## STAFF REPORT

**SUBJECT:** Consideration for Preliminary Plat Amendment approval of a five (5) lot residential subdivision known as Kaysan Cove, located generally at 6573 W Rose Canyon Road in the A-1-10 (Agricultural) Zone. **(Public Hearing)**

**File Number:** S2023-008

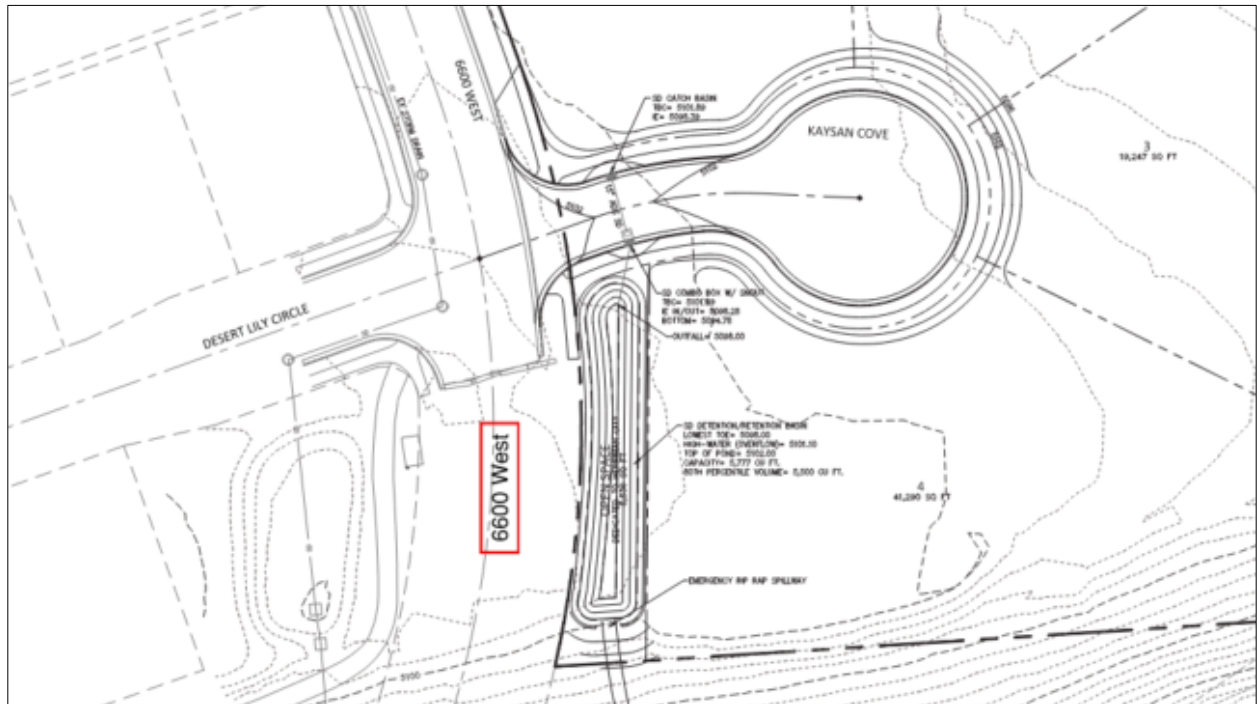
**Staff Finding:** *The applicant is improving and dedicating approximately 0.11 acres of property to the City to align the sidewalk and park strip with the adjacent development (shown in blue). An additional forty-four (44') feet, or as required, (extending into Rose Canyon Road) of right-of-way (ROW) improvements along Rose Canyon Road, including curbs, gutters, and asphalt, will also be installed (shown in red). However, the applicant has requested a deviation of the road standard to reduce the required asphalt improvements along Rose Canyon Road. The applicant shall install all ROW improvements as submitted unless the City Council grants a deviation to the road section.*

*Due to the unknown alignment of the future bridge over Midas Creek connecting Blayde Drive (6600 West), the applicant will have to pay a fee in lieu of the improvements along 6600 West.*
